PERFORMANCE SPECIFICATION SHEET

SOCKET, PLUG-IN ELECTRONIC COMPONENTS,
FOR RELAYS, 3-POLE, 25 AMPERES
(MIL-R-6106 AND MS27743)

This amendment forms part of MIL-PRF-12883/48B, dated 28 June 1996 and is approved for use by all Departments and agencies of the Department of Defense.

Figure 4, Stud fixed, delete and substitute the figure with figure below.

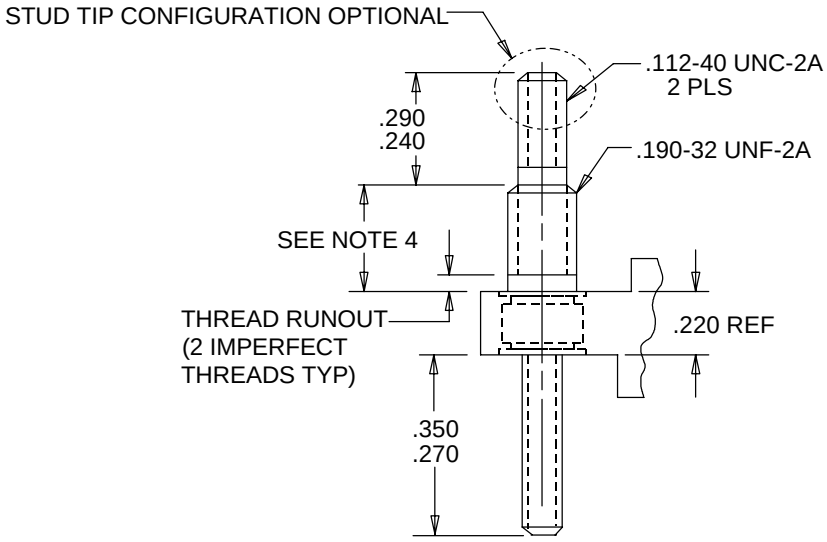
Figure 4, Stud fixed, add notes to drawing.

NOTES
1. Dimensions are in inches.
2. Metric equivalents are for general information only.
3. Unless otherwise specified, tolerances are ±.005 inch (0.25 mm) for three place decimals and ±.01 inch (0.25 mm) for two place decimals.
4. .318 ±.010 inch (8.08 ± .0.25 mm) from top of socket flange to base of .112-40 UNC-2A thread for -04 and -08, and .290 ±.010 inch (7.37 ±0.25 mm) for -02 and -06.

Figure 5, Stud loose, delete and substitute the figures with figures below:

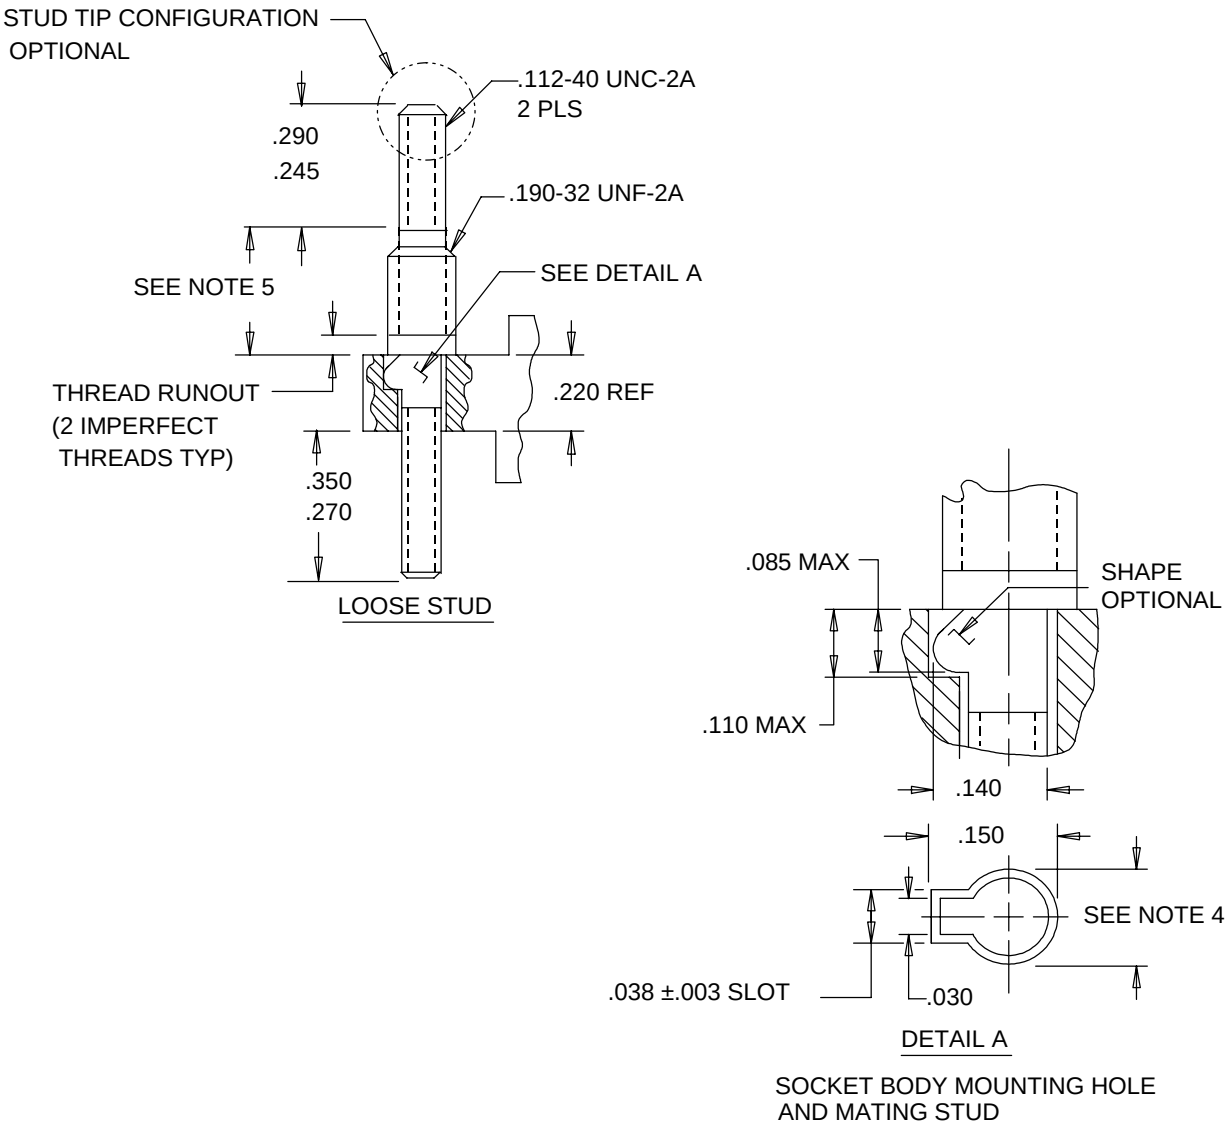
Notes 4 and 5, delete and substitute:

4. The diameter for the loose stud mating hole in the socket body shall be:
   for -03, AND -07 diameter shall be .125±.003 inch (3.18 ±0.08 mm),
   for -01, and -05, diameter shall be .116±.003 inch (2.95 ±0.08 mm).
5. .290 inch (7.37 mm) for -01, -02, -05, and -06 .318 inch (8.08 mm) for -03, -04, -07, and -08 sockets.
